REMEDIAL INVESTIGATION WORK PLAN GENT UNIFORM RENTAL SERVICE 5680 MERRICK ROAD MASSAPEQUA, NEW YORK

August 29, 2002

RI Work Plan, July 12, 2002

Gent Uniform Rental Service, #130056

FIGURE 7B - PROPOSED
GROUNDWATER SAMPLE LOCATIONS

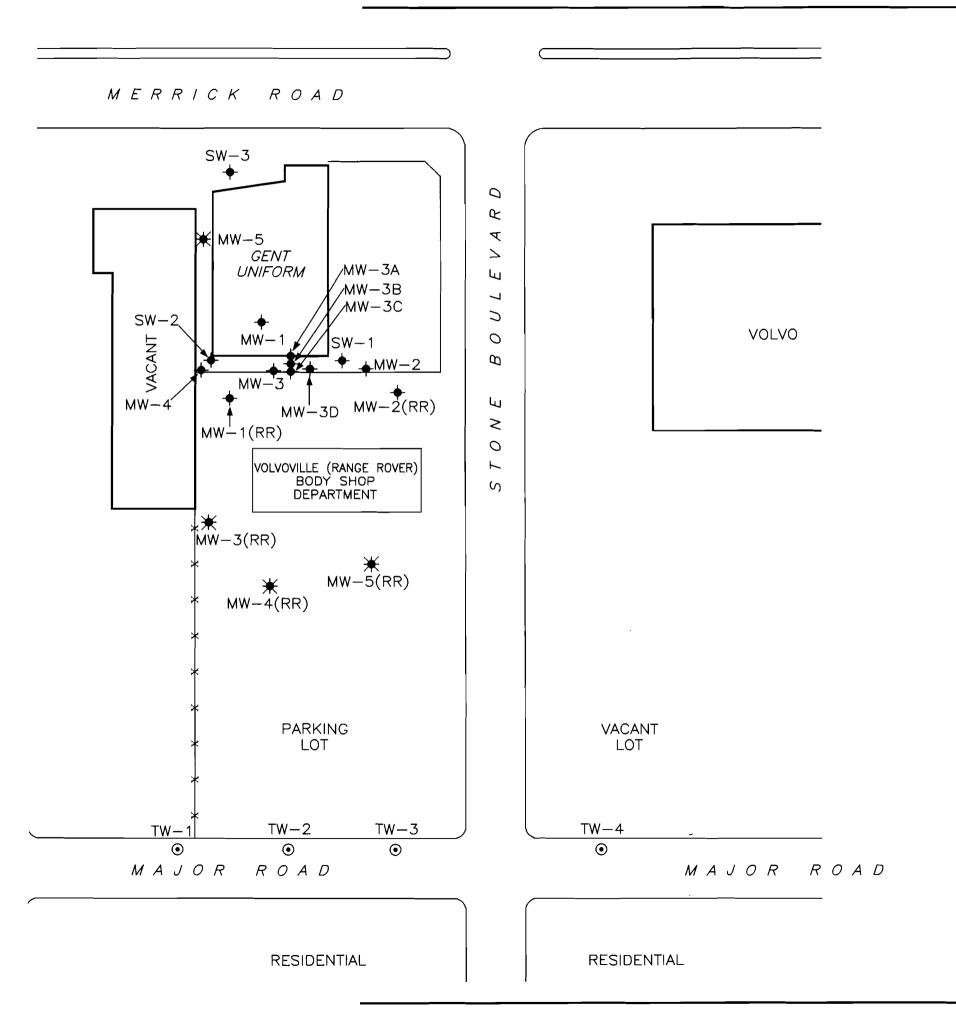
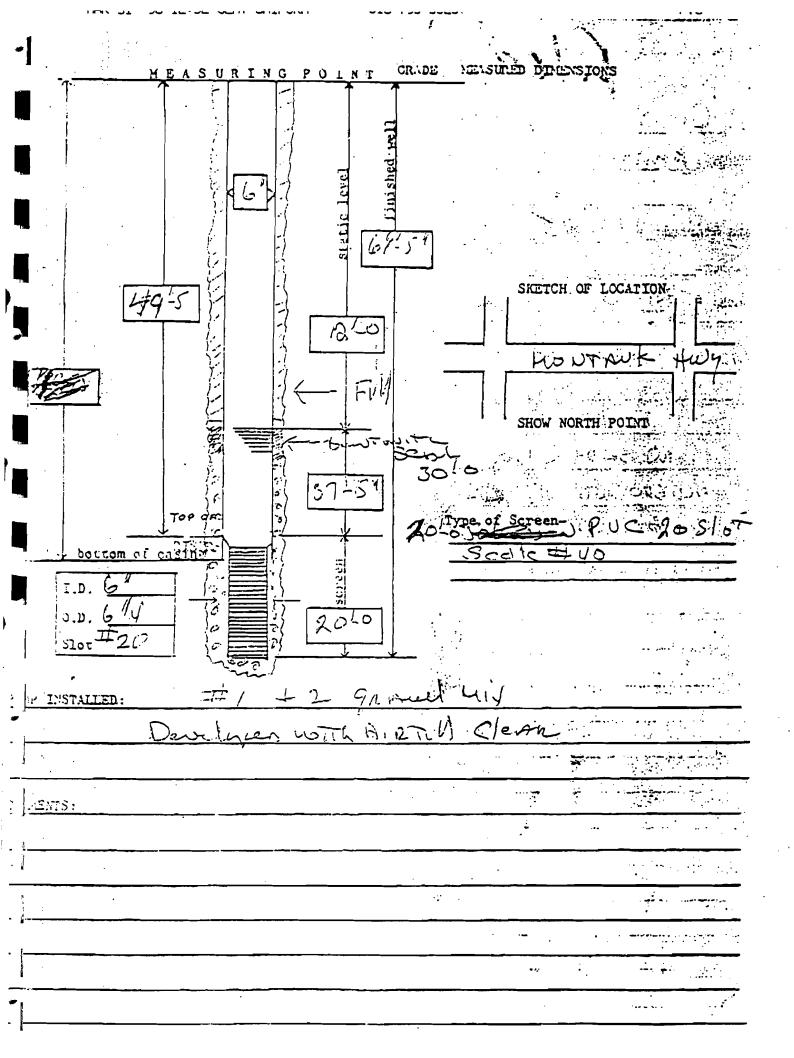
- 1) The need for additional wells along Major Road will be determined based upon the geoprobe groundwater sampling results along Major Road. The NYSDEC will be consulted on the need for these wells. Please note that any significant detections above groundwater standards will necessitate the construction of at least one well so that the groundwater at this location can be periodically sampled. If the current monitoring network is inadequate to accurately determine the groundwater flow direction, at least two wells may be needed on Major Road.

- 2) The need for additional downgradient (south of Major Road) geoprobe points and/or monitoring wells will be based upon the groundwater sampling results from Major Road. The NYSDEC will be consulted on the need for this sampling.
